SUBJECT: AMENDMENT NO. 131 TO FACILITY OPERATING LICENSE NO. NPF-3
(TAC NO. 65374)

DAVIS-BESSE NUCLEAR POWER STATION, UNIT NO. 1

SAFETY EVALUATION BY THE OFFICE OF NUCLEAR REACTOR REGULATION
RELATED TO AMENDMENT NO. 131 TO FACILITY OPERATING LICENSE NO. NPF-3

Davis-Besse Auxiliary and Motor Driven Feedwater Systems

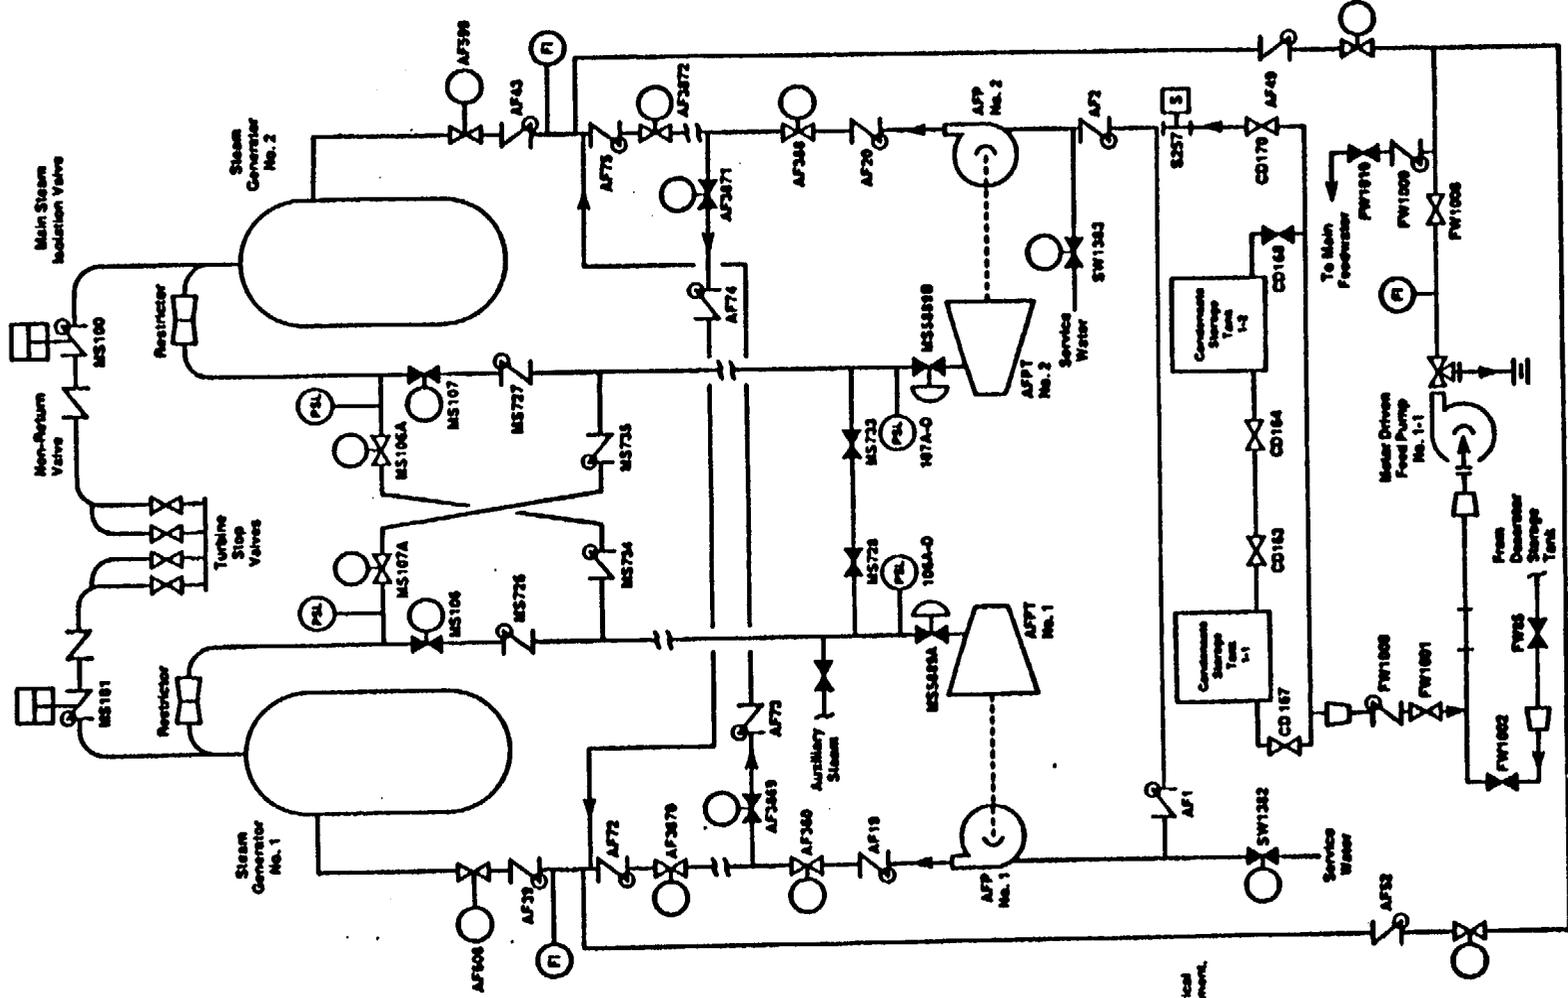
The present Davis-Besse Auxiliary Feedwater (AFW) system is shown in Figure 1, attached. Prior to the June 9, 1985 loss-of-feedwater event, valves MS-106, MS-106A, MS-107 and MS-107A, on the steam admittance lines to the AFW pump turbines, were retained in closed position. Thus, the portion of the steam admittance lines downstream of these valves remained at ambient pressure. Pressure switches PSL 106A through 106D were interlocked with motor operated steam admission valves MS 106 and MS106A while PSB 107A through 107D were

interlocked with steam admission valves MS 107 and MS 107A. These switches are designed to initiate closure of these four steam admission valves (or to maintain closure if already closed) in the event they detect low pressure. As initially designed, the steam admission valves were closed, and opened in response to a steam and feedwater rupture control system (SFRCS) signal. The pressure switches, originally in the tripped position because of sensing ambient pressure moved into the untripped position as a result of the pressure of the steam being admitted. Thereafter, a break in a steam admittance line which results in a lower pressure would cause the pressure switches to move into the tripped position, initiating closure of the steam admittance valves in the broken line.

It should be noted that the two air-operated valves, MS 5889 A and B shown on Figure 1 downstream of the pressure switch interlocks, were not part of that original design; they were introduced as part of the new design after the June 9, 1985 LOFW event and supplemented two manually operated valves which were kept in the open position. The new design also required that steam admittance valves MS 106A and 107A be kept open with MS 5889 A and B in the closed position. This has the effect of maintaining steam pressure in the lines up to valves MS 5889 A and B. Thus, while the pressure switches previously had to switch position from tripped to untripped in order to permit AFW system operation, now they remain in the untripped position and only operate (trip) in the event of a low pressure signal to shut off steam flow to the broken line.

Therefore, the AFPT inlet steam pressure interlocks are no longer required for the AFW system to be operable.
